**BEFORE
THE PUBLIC SERVICE COMMISSION OF
SOUTH CAROLINA**

DOCKET NOS. 2021-88-E

DIRECT TESTIMONY OF ED BURGESS

THE CAROLINAS CLEAN ENERGY BUSINESS ASSOCIATION

Figure 1. Comparison of modeled incremental Operating Reserves assumed in DESC's VIC Analysis to the incremental reserves that would be held according to DESC's operating practices.

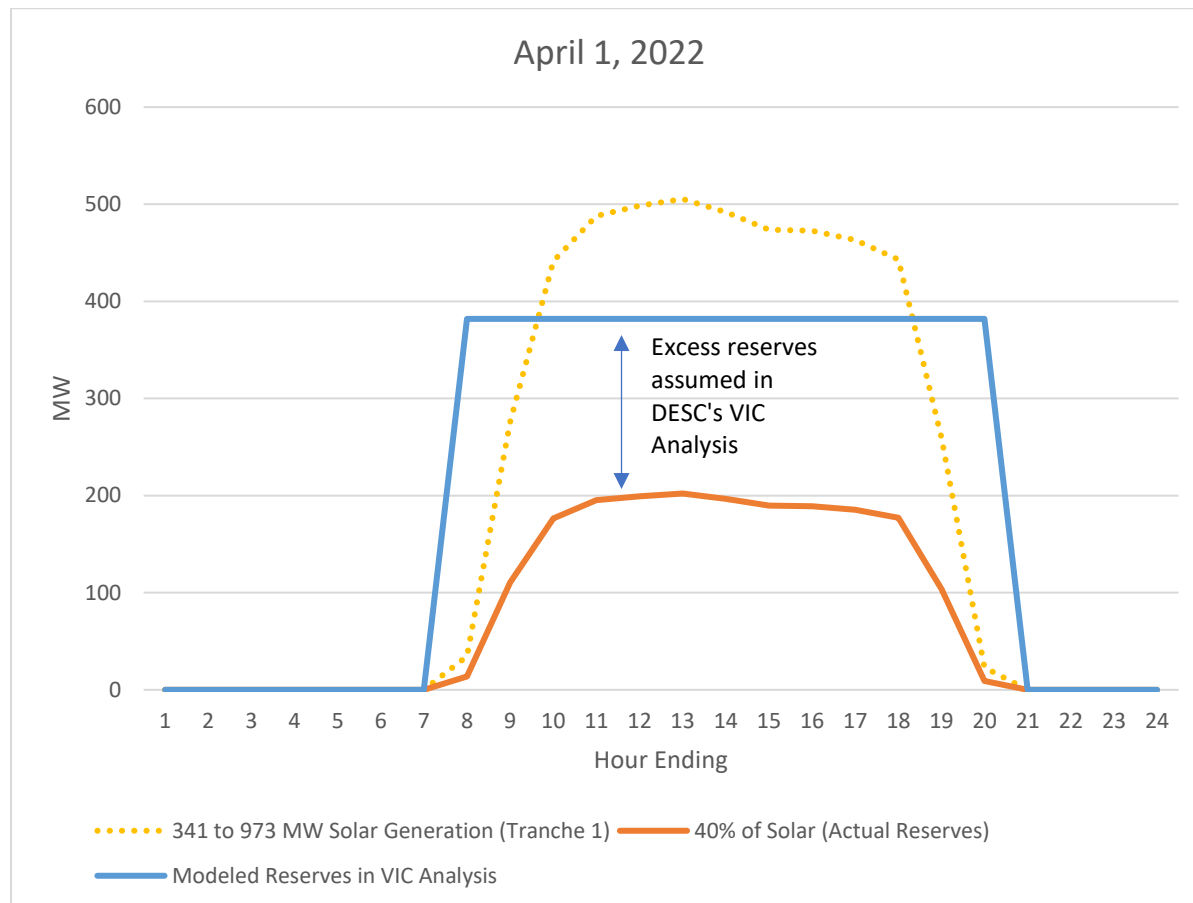
A. Yes. The chart below provides an illustrative example of how DESC's VIC analysis includes extremely inflated estimates of incremental operating reserve requirements for solar. On this chart, the yellow dotted line is a plot of estimated hourly solar generation from Tranche 1 facilities for a day in April 2022. The data used to generate this plot were taken directly from DESC's VIC workpapers and reflects the exact amount of Tranche 1 solar production included in Guidehouse's model for this day. Meanwhile, the orange line reflects the corresponding amount of operating reserves DESC's system operators would be likely to hold to accommodate Tranche 1 solar. As explained above, the standard practice of DESC's system operators is to hold "operating reserves in the amount of 40% of the hourly solar forecast or 40% of actual solar generation" in order to account for solar variability. The orange line in the chart represents 40% of the modeled solar generation. Finally, the blue line represents the incremental operating reserves assumed by Guidehouse to model integration costs. As noted in Exh. PBD-2 Table 9, the incremental operating reserves for Tranche 1 were assumed to be 382 MW for the month of April.³ What is readily apparent from this chart is the stark difference between the orange and blue lines, revealing how much higher the operating reserves are in the Guidehouse analysis when compared to what is more realistic based on DESC's actual operating practices. In fact, for this particular day, the excess in modeled operating reserves ranges from 89% higher to 4,041% higher than what is realistic based on DESC's actual operating practices.

While this represents an illustrative example for a single day, this pattern exists for every day in DESC's analysis.

A. As explained above, the Guidehouse analysis assumes grossly inflated operating reserve requirements that do not match DESC's actual operating practices. These flawed assumptions in turn lead to a grossly inflated and incorrect VIC charge calculation. As such, the Guidehouse analysis and resulting VIC charge cannot be viewed as a credible representation of any integration costs DESC is likely to incur. Accordingly, I recommend that any increase in the VIC for Tranche 1 should be rejected and instead my analysis (presented in Section 8 below) should be adopted. While there are many reasons for rejecting DESC's proposal, chief among them is the fact that DESC did not present historical data demonstrating that the total operating reserves it has deployed in recent years have increased due to solar (let alone that any such increases were necessary and consistent with industry best practices). Furthermore, DESC did not demonstrate that the operating reserve assumptions used in Guidehouse's VIC Tranche 1 analysis are in any way reflective of the way DESC operates its system to accommodate solar. Finally, for future Tranche 2 (and above) facilities, I believe that any VIC charge exceeding the levels I have recommended in Section 8 may also be premature until DESC has completed a historical analysis of actual integration costs consistent with Order No. 2020-244.
